UNITED STATES
NUCLEAR REGULATORY COMMISSION
WASHINGTON, D. C. 20555
December 17, 1980

The Nuclear Regulatory Commission has issued Amendment Nos. 44 and 38 to Facility Operating License Nos. DPR-42 and DPR-60 for the Prairie Island Nuclear Generating Plant, Unit Nos. 1 and 2, respectively, in response to your application dated May 6, 1980 as supplemented September 19 and December 2, 1980.

The amendments revise the common station Technical Specifications for the Prairie Island Nuclear Generating Plant Unit Nos. 1 and 2 with respect to the current logic for actuation of safety injection and with respect to the control rod and power distribution limits. During our review of your proposed amendments we found that certain modifications were necessary to meet our requirements. Your staff has agreed to these modifications and they have been incorporated in these amendments.

ATTACHMENT TO LICENSE AMENDMENTS NOS. 44 AND 38

FIGURE TS.3.10-7

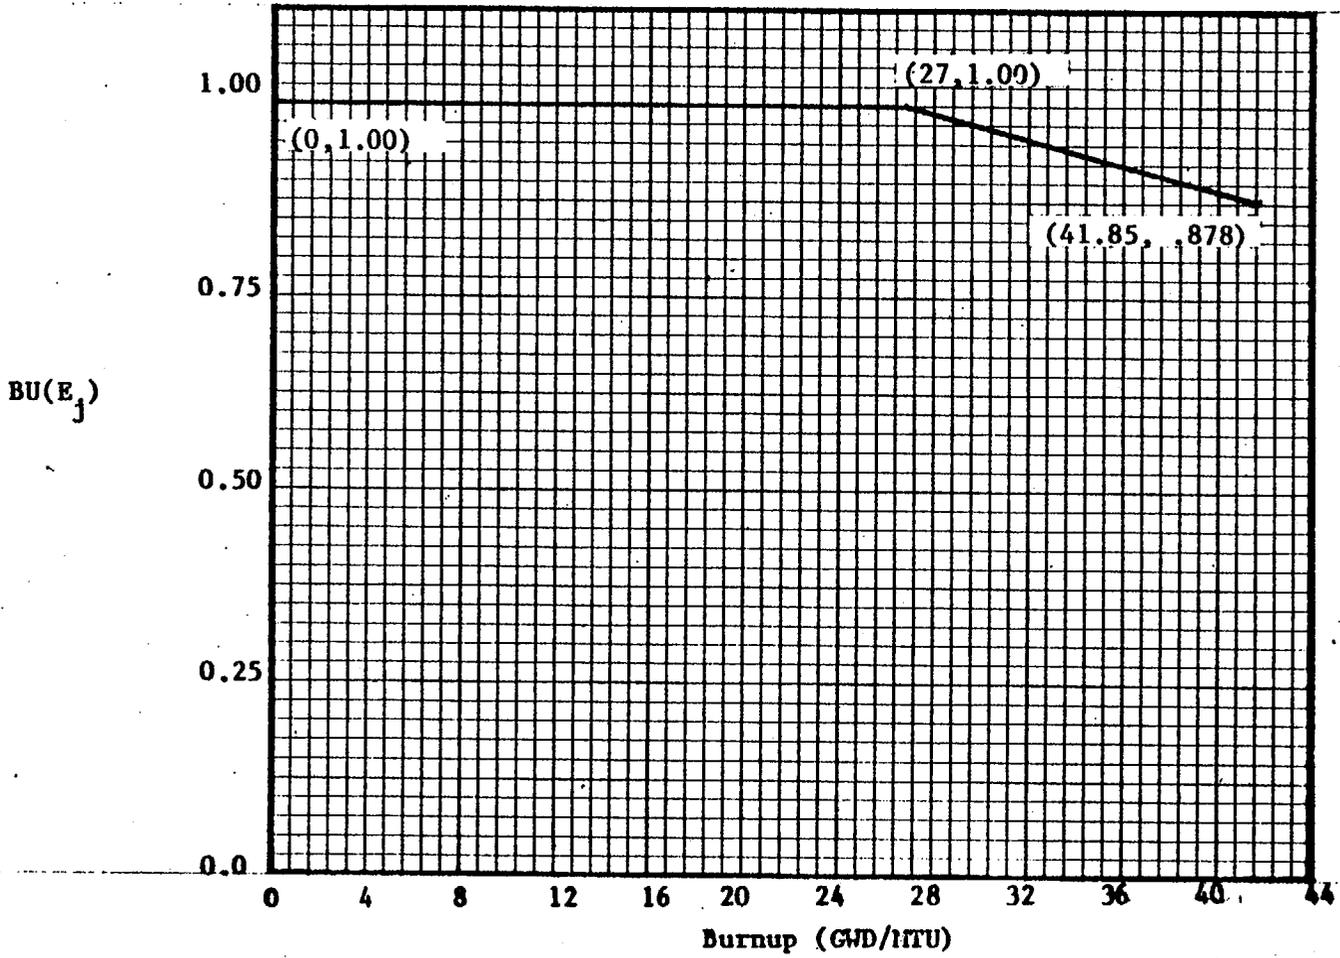
The $BU(E_j)$ function shown in Figure TS.3.10-7 is a normalized function that limits $F_0(Z)$ based on exposure dependent analyses for the ENC fuel. These analyses consider pin internal pressure uncertainties, fuel swelling, rupture pressures, and flow blockage.

The licensee proposes to add an exposure dependent function which limits F_Q^N toward the top of the core at high exposures. This was done to conform with the NRC high fission gas release model. We reviewed the licensee's application of this model and agree that he has performed a conservative
